Re: Seminole Electric Cooperative, Inc.
Midulla Generating Station, Hardee County Florida
Power Plant Certification No. PA89-25F
Post-Certification Amendment to Application

Re: Seminole Electric Cooperative Inc.'s Midulla Generating Station (MGS)
Stormwater Analysis for Entrance Road Modification and Sodium Hypochlorite
Unloading Containment

FIGURE 2.
UNLOADING CONTAINMENT
MIDULLA STATION
Source: SECI, 2016; IBC consulting, 2016.

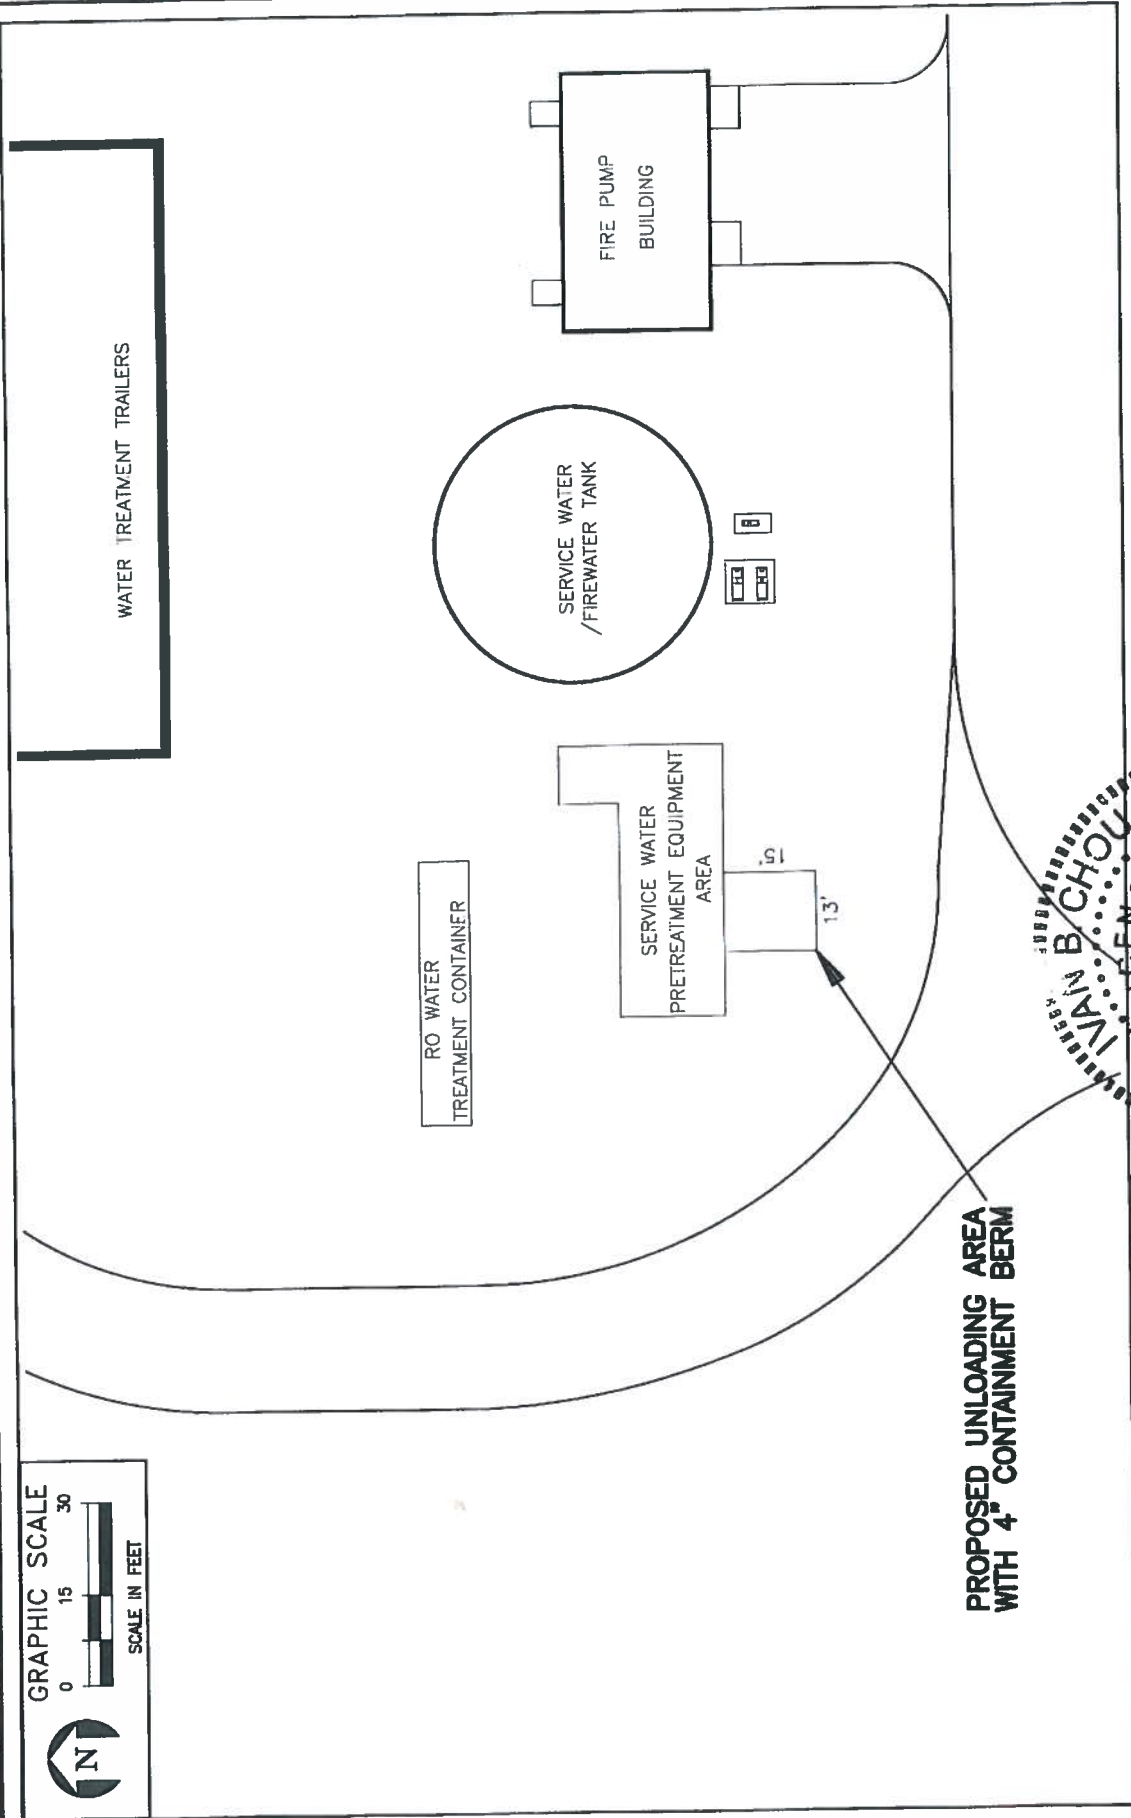
The proposed containment area for sodium hypochlorite unloading will be adjacent to an existing sodium hypochlorite tank near the northwest portion of the MGS site within the service water pretreatment area (see figure 2 of the attached report). The containment area would help to control incidental spills during unloading operations. The size of the containment area will be 13ft x 15ft, with a 4 inch berm.

2. There is an existing sodium hypochlorite tank near the northwest portion of the MGS site within the service water pretreatment area. SECI plans to construct a concrete-paved unloading area, with the containment berm, adjacent to the tank to control incidental spills during unloading operations. In the event of an incidental spill, the spilled chemical will be contained, cleaned up, and transported to an approved disposal/treatment site by approved contractors. The size of the containment area will be 13 ft by 15 ft, and the height of the containment berm will be 4 inches. The location of the proposed containment area is shown in Figure 2.
